# 595 Old County Rd. Renovation Project Narrative:

# Fwd: [EXTERNAL] Armstrong Kitchen Renovation - July 2nd SHPC Meeting Cancellation

Good morning - I'm looking through the application packet and have a few questions:

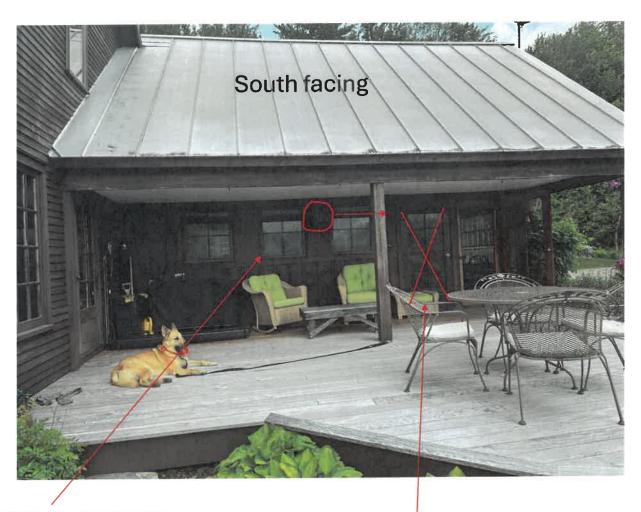
The homeowners wanted this window to be able to operate, so there are proposed to be two double hung units flanking a picture window, non operational, in the middle.

This proposed window change would make the homeowner's view from the kitchen sink less obstructed. The sconce light in between the windows (circled) is planned to move to the right of the new bank of windows.

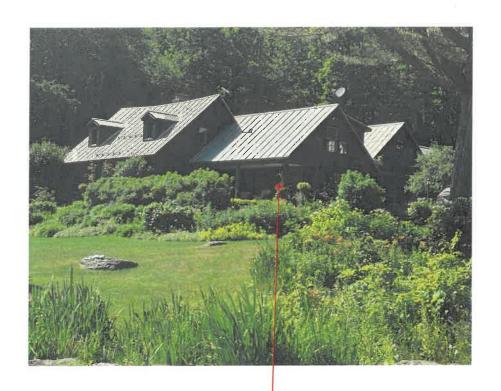
We propose to remove this faux wooden chimney that encloses a stovepipe for a stove that is no longer installed in the house, on a section of house that was built in 1997.

Since the homeowner would like more protection from the elements when entering or exiting this door, we propose a roof overhang that extends about two feet with a bracket on the right side to help support it, like the one that is circled. The roofing would be removed and replaced with the same standing seam.
